UNITED STATES PATENT AND TRADEMARK OFFICE

10/579,528

Office Action Summary	Application No. 10/579,528	Applicant(s) ALBRECHT ET AL.	
	Examiner PHILLIP NGUYEN	Art Unit 2828

DETAILED ACTION

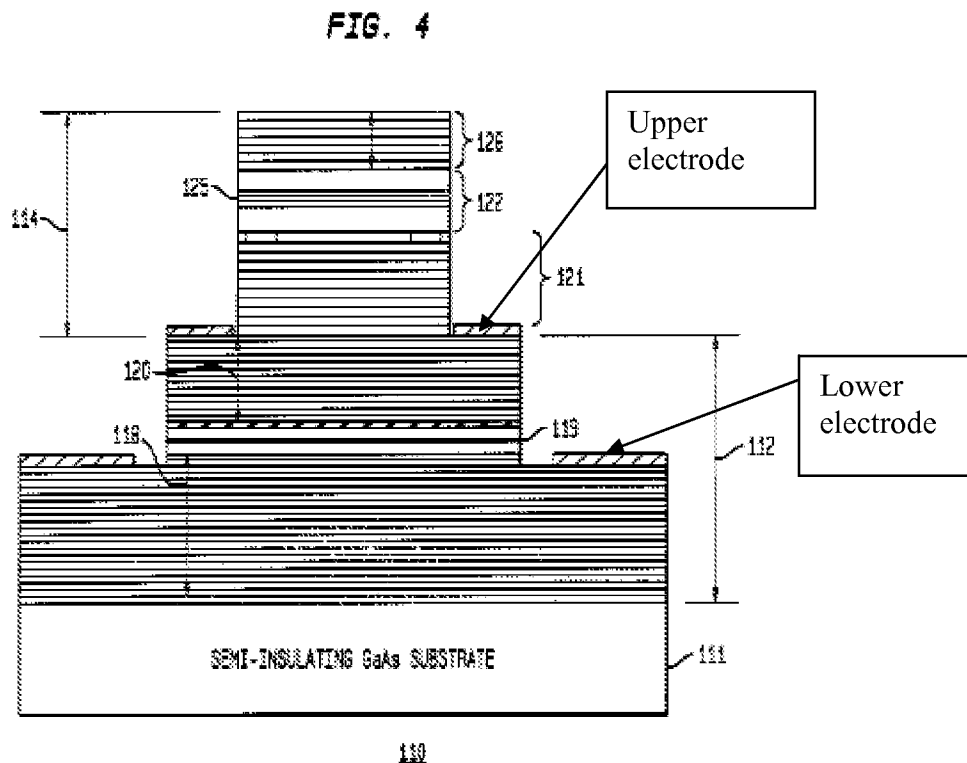
With respect to claim 1, Cunningham discloses in Fig. 4 a semiconductor laser device comprising:

an optically pumped surface-emitting vertical emitter region 114 which has an active radiation-emitting vertical emitter layer 175; and

at least one monolithically integrated pump radiation source 112 for optically pumping the vertical emitter, which has an active radiation-emitting pump layer 119, wherein the pump layer 119 follows the vertical emitter layer 125 in the vertical direction;

a conductive layer (upper electrode) provided between the vertical emitter layer 114 and the pump layer 119; and

a contact (lower electrode) is applied on the side of the semiconductor layer device which is closer to the pump layer than to the conductive layer;

whereby an electrical field can be applied between the conductive layer and the contact for generating pump radiation by charge carrier injection.

With respect to claim 8, Cunningham discloses a vertical waveguide structure 121 is provided between the vertical emitter layer 125 and the conductive layer (lower electrode).

With respect to claims 11-12, Cunningham discloses the pump layer and the vertical emitter layer being followed in the vertical direction by an internal cavity reflective structure which is a Bragg reflector structure 118.

With respect to claim 13, it is clear in Fig. 4 that the internal cavity structure 118 is arranged between the vertical emitter layer 125 and a substrate 111 and the radiation generated by the vertical emitter layer is launched on the side opposite the substrate.

FIG. 3

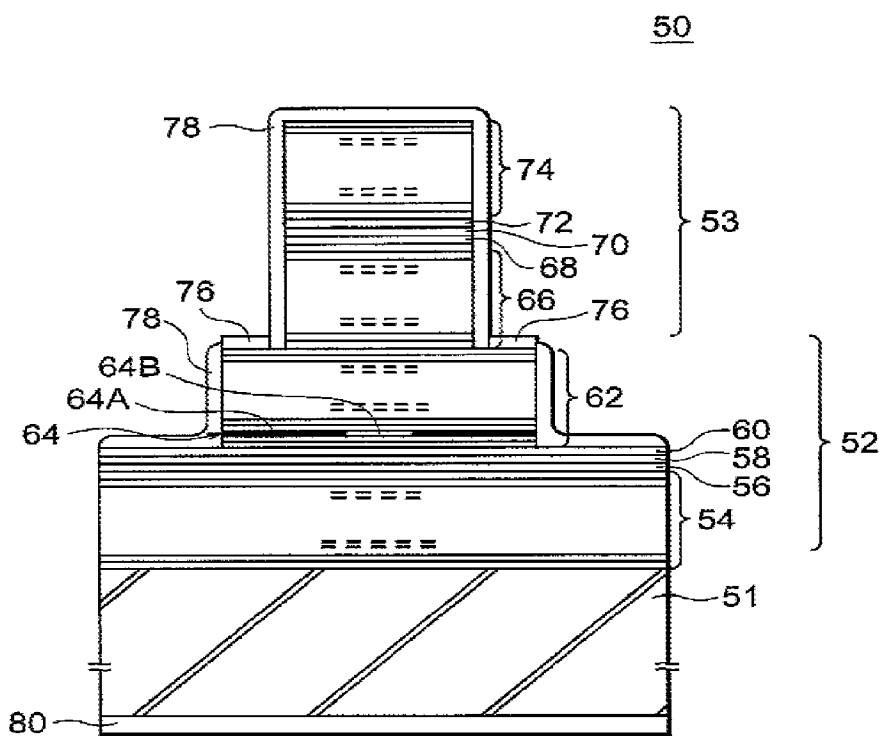
With respect to claim 1, Iwai discloses in Fig. 4 a semiconductor laser device comprising:

an optically pumped surface-emitting vertical emitter region 53 which has an active radiation-emitting vertical emitter layer 70; and

at least one monolithically integrated pump radiation source 52 for optically pumping the vertical emitter, which has an active radiation-emitting pump layer 58, wherein the pump layer 58 follows the vertical emitter layer 70 in the vertical direction;

a conductive layer 76 provided between the vertical emitter layer 70 and the pump layer 58; and

a contact 80 is applied on the side of the semiconductor layer device which is closer to the pump layer than to the conductive layer;

whereby an electrical field can be applied between the conductive layer and the contact for generating pump radiation by charge carrier injection.

FIG. 3B

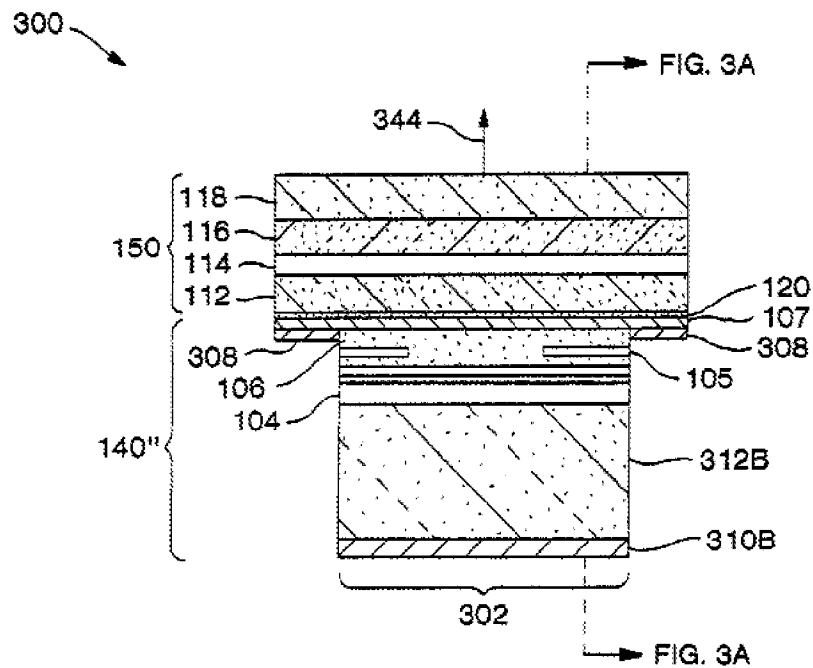
With respect to claim 1, Jiang discloses in Fig. 3B a semiconductor laser device comprising:

an optically pumped surface-emitting vertical emitter region 150 which has an active radiation-emitting vertical emitter layer 114; and

at least one monolithically integrated pump radiation source 140” for optically pumping the vertical emitter, which has an active radiation-emitting pump layer 104, wherein the pump layer 104 follows the vertical emitter layer 114 in the vertical direction;

a conductive layer 107 provided between the vertical emitter layer 114 and the pump layer 104; and

a contact 310B is applied on the side of the semiconductor layer device which is closer to the pump layer than to the conductive layer;

whereby an electrical field can be applied between the conductive layer and the contact for generating pump radiation by charge carrier injection.

With respect to claims 2 and 4, Jiang discloses the semiconductor laser device is partially ablated so that the conductive layer 107 is partially exposed (paragraph 0044) and a further contact 308 is applied to the exposed areas of the conductive layer 107.

With respect to claim 7, Jiang discloses the conductive layer 107 being arranged vertically in such a manner that is located in a node of the radiation field in the resonator of the vertical emitter region.

With respect to claim 8, Jiang discloses a waveguide structure 112 being provided between the vertical emitter 114 and the conductive layer 107.

With respect to claim 9, since the waveguide structure 112 being aligned with both contact 310B and further contact 308.

With respect to claim 10, since the vertical waveguide structure 112 made of material containing Aluminum (paragraph 0037), it is believed that the waveguide structure 112 is oxidized.

FIG. 2

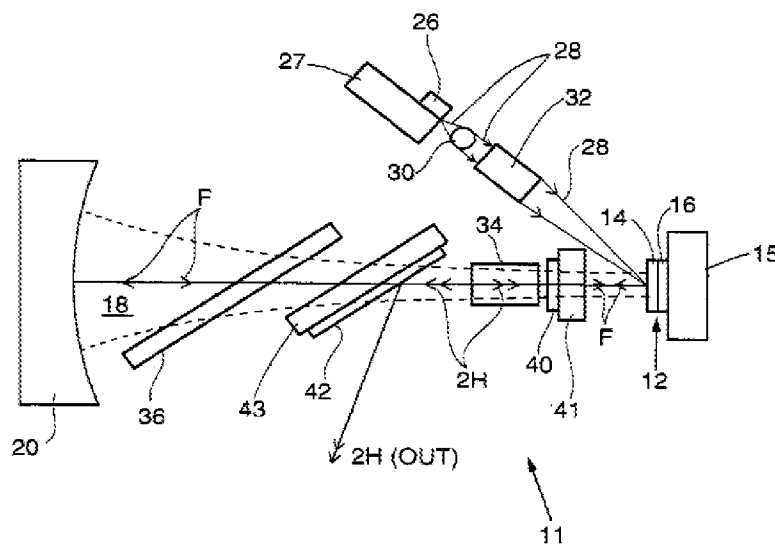
Cunningham discloses the claimed invention except for the vertical emitter being associated with an external resonator reflector which together with the internal cavity reflective structure, forms a resonator for the vertical emitter region, beam-shaping elements, frequency-selective elements, and frequency-converting elements are arranged in the resonator. Spinelli discloses a VCSEL as shown in Fig. 2 with an external cavity including an external resonator mirror 20, and frequency-converting element 34, frequency selecting elements 36, 40, 42.

It would have been obvious to one skill in the art at the time the invention was made to provide an external resonator reflector and the listed components inside the resonator because it has been known in the art to use an external resonator to obtain desired laser light through the
